FOR K82

Update R2.0

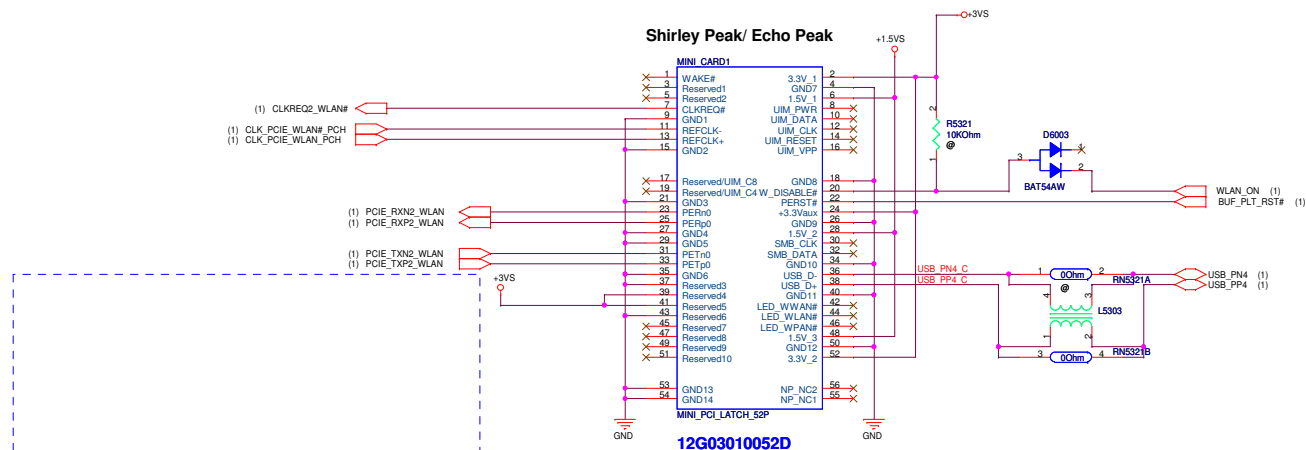
目前 BT Spec. 1.2 以上, 皆支援 AFH(Auto Freqenct Hopping), 會自動跳開環境所有的 Wi-Fi 干擾源頻率。
So 從前的BT Module 到 Wi-Fi Module 的兩條 Signals 可以不用再接了! (目前的 BT Chip 至少都有 support 到 BT 2.0以上)

關於PIN 3 PIN5的說明

Update 0910 (R2.0)

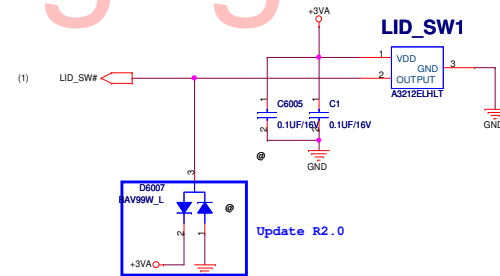
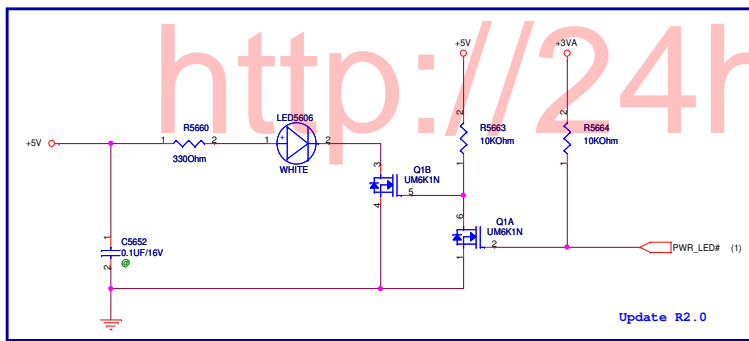
WLAN nuts:

Minicard spec R1.2:

Full size card= 2pcs.

Half size card= 2pcs.
